# Springbank Off-stream Reservoir Project

Response to  
Agency Conformity  
Review of  
Round 1 Part 3,  
dated August 21, 2019

November 2019

Figure 24-1

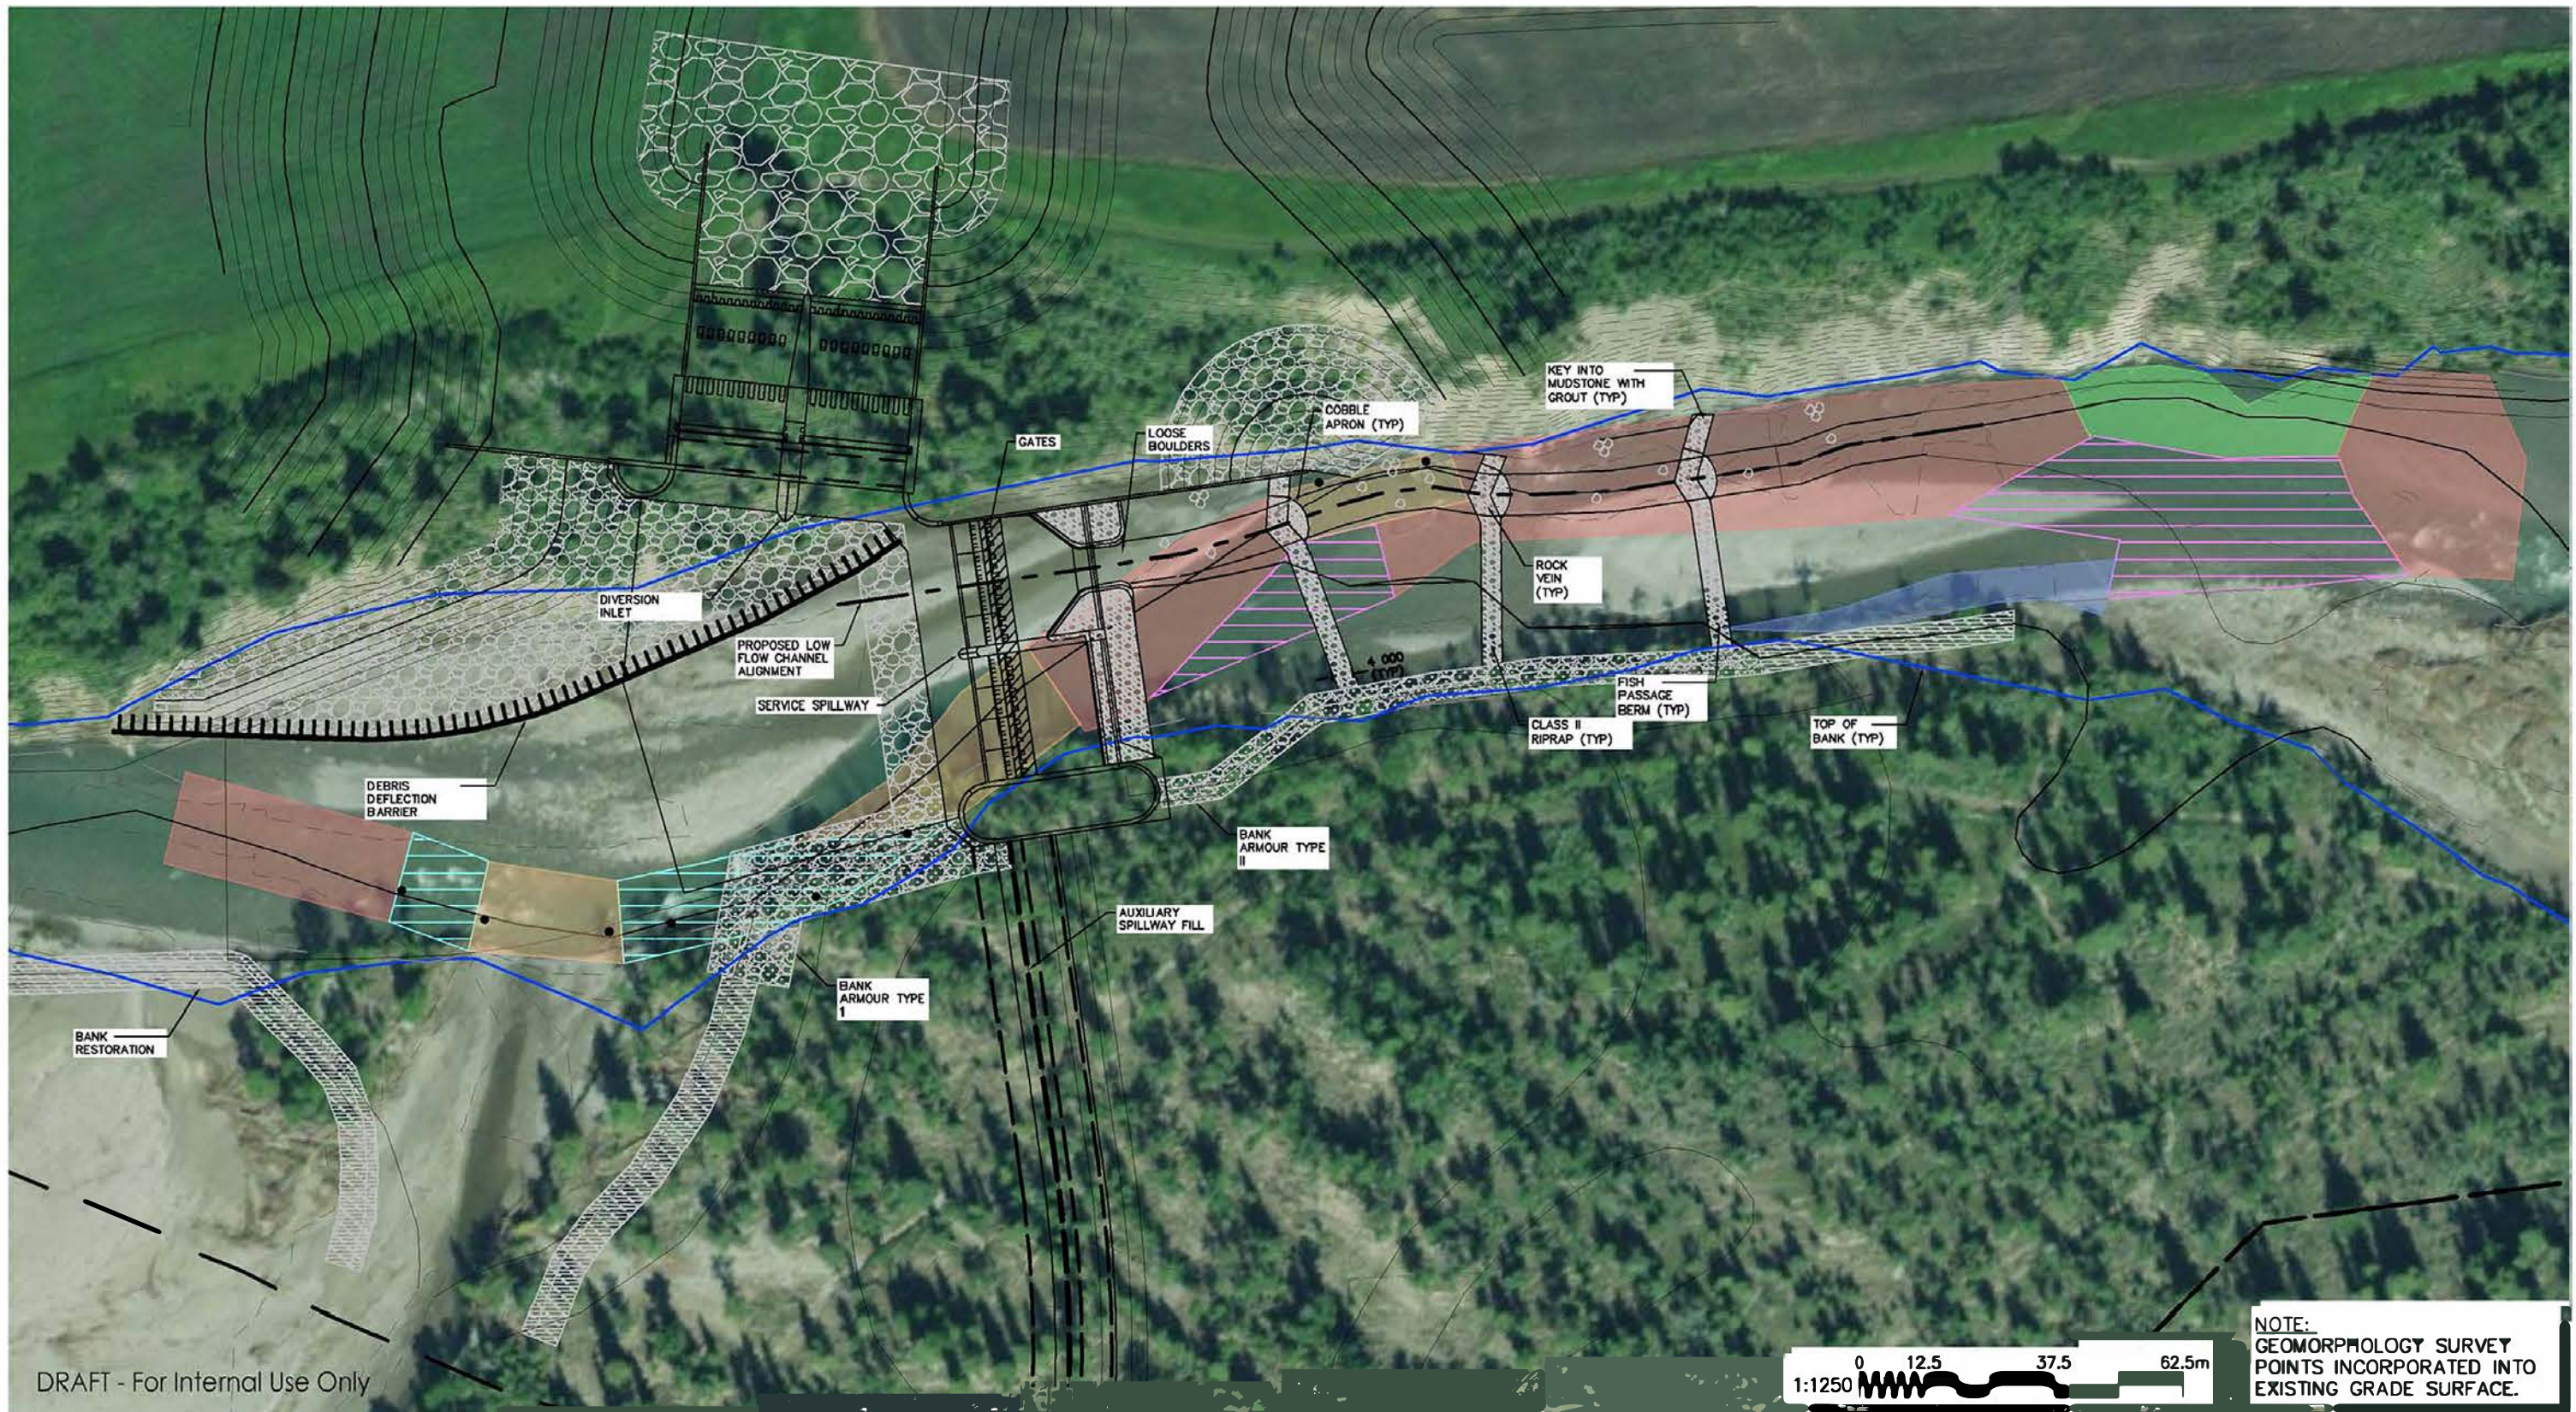
- a) Provide table summarizing all destruction and permanent alternation to fish habitat resulting from all project components and project operations.**
- b) Explain potential effects of operation of the obermeyer gates and design of fish passage mitigation measures to constrict flow to the thalweg on the north bank of the river on the potential spawning riffle downstream of the diversion structure.**

- a) Project components and associated aquatic habitat in the footprint area are listed in Table 24-1. The information relevant to the footprint area in Elbow River is also illustrated in Figure 24-1. The relationship (i.e., interconnection) between the placement of temporary and permanent structures, the river channel morphology, and fish habitat is dependant on dynamic river processes. Instream changes due to Project infrastructure will affect stream flows that rearrange mobile substrates, thus redistributing or changing the nature of channel units and effects on fish habitat.

the bed structures within the channel includes areas considered bar habitat and unavailable for much of the year and therefore, potential footprint related effects are low. Figure 24-1a illustrates the habitat types in relation to Project footprint components.
